February 9, 1993
LD-93-016

Docket No. 52-002

SUBJECT: Revisions to CESSAR-DC Chapter 15 Safety Analyses Results

REVISIONS TO CESSAR-DC CHAPTER 15

FIGURE 15.5.2-1

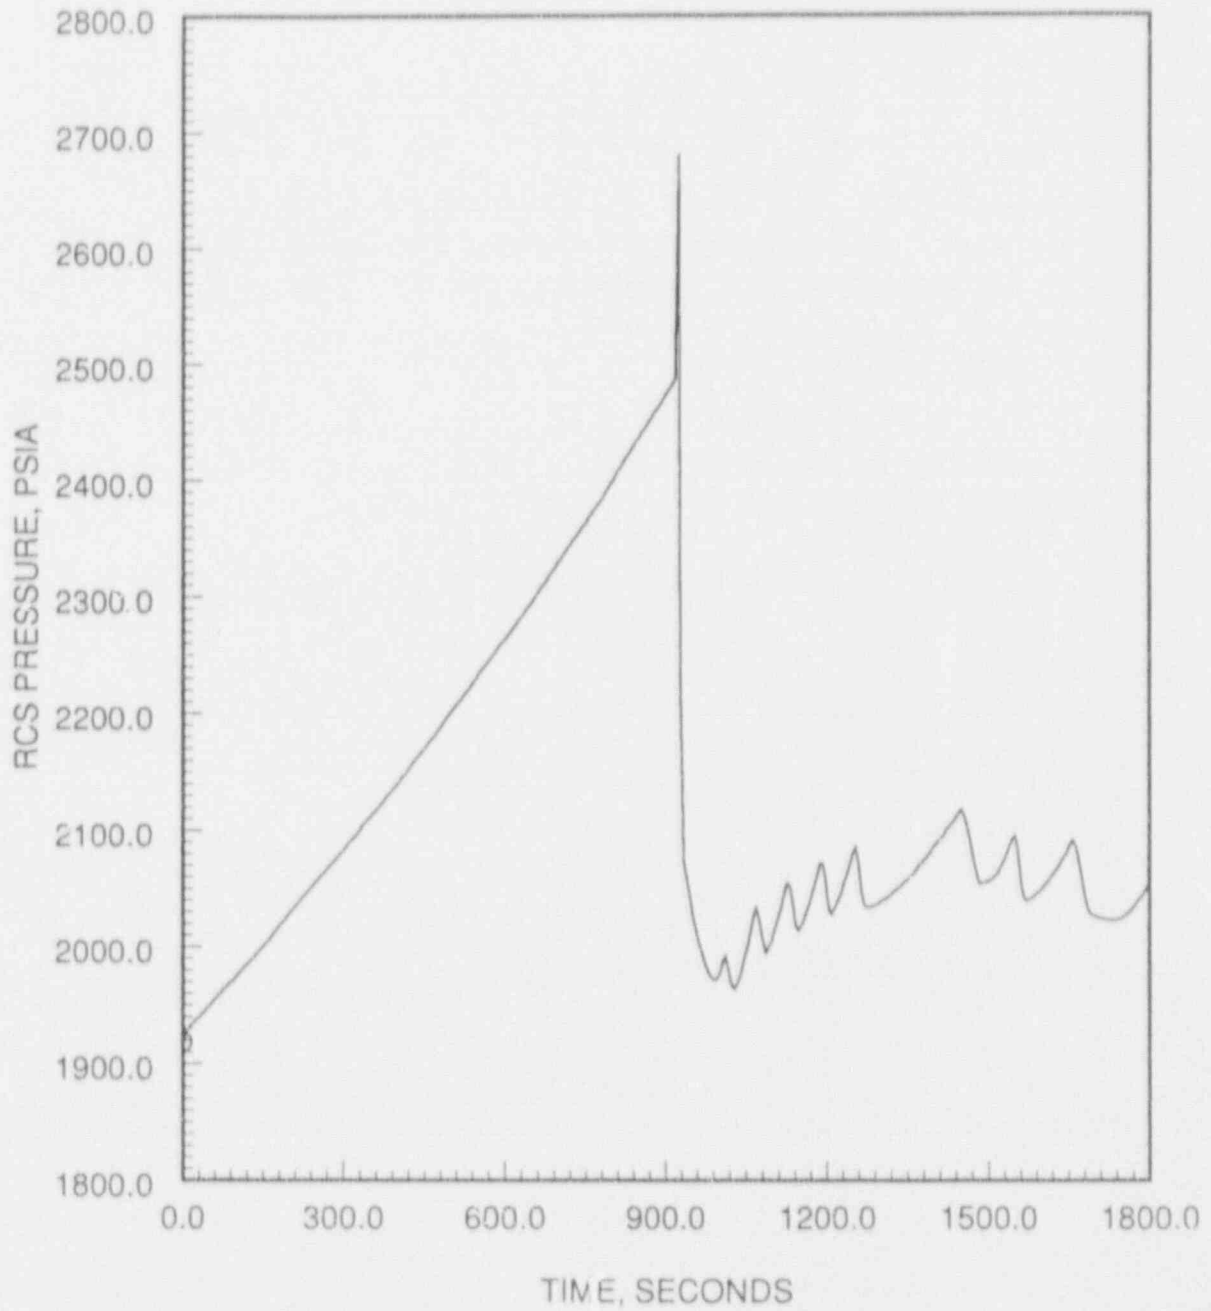
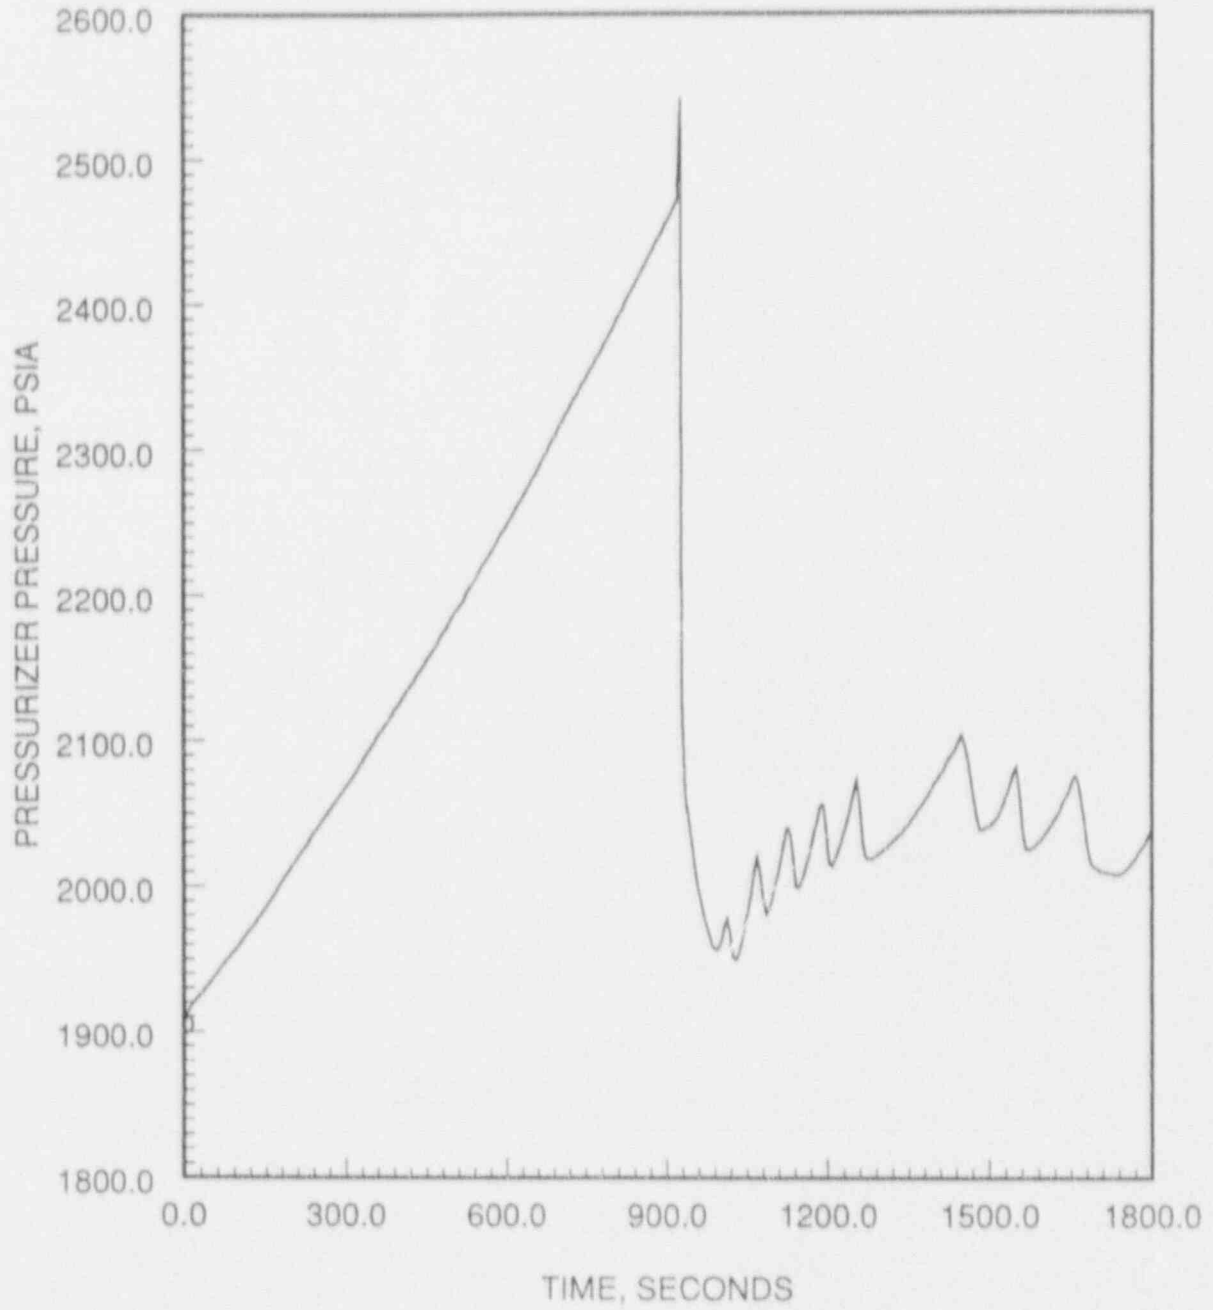
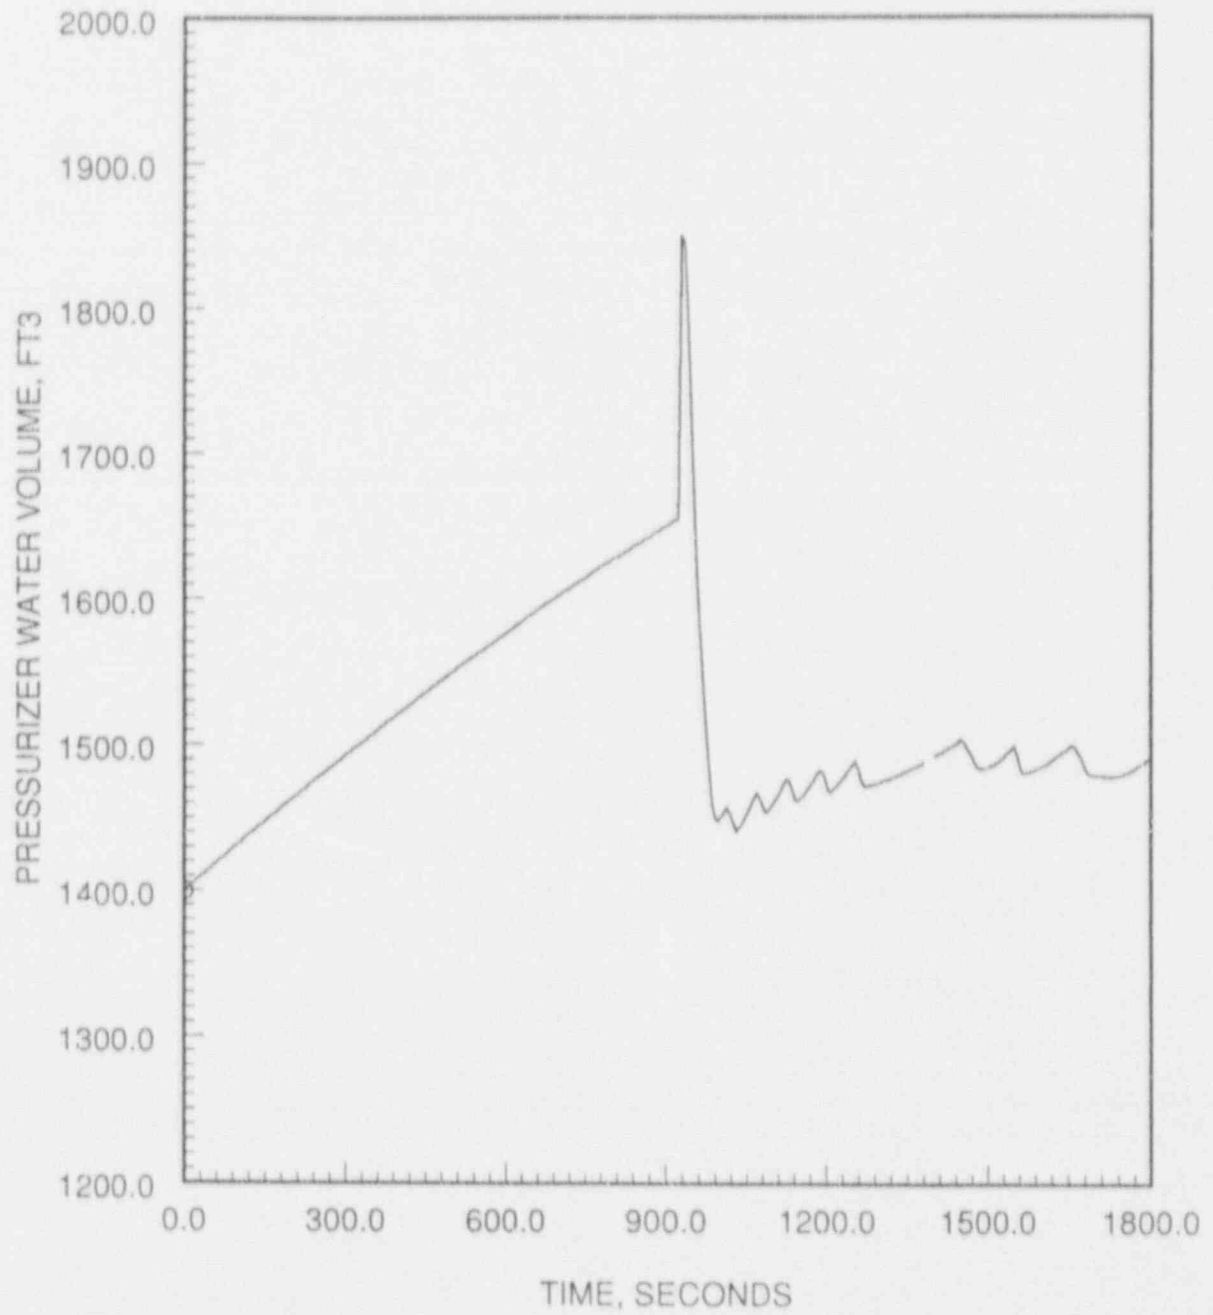
The event was analyzed assuming a failure in the pressurizer pressure and level control systems such that the pressurizer heaters failed to turn off and the charging flow was maximized and the letdown flow minimized. This resulted in the continuous filling of the pressurizer. The maximum RCS pressure was determined to be 2680 psia. The maximum steam generator pressure was determined to be 1267 psia. These values are less than 110% of the design pressures for the primary and secondary systems, respectively. The minimum DNBR was determined to remain above the SAFDL; thus, no fuel failures need be assumed. Table 15.5.2-1 presents the sequence of events and Table 15.5.2-2 lists the assumptions and initial conditions used for this analysis. Figures 15.5.2-1 through 15.5.2-3 present the dynamic response of the system to this event.
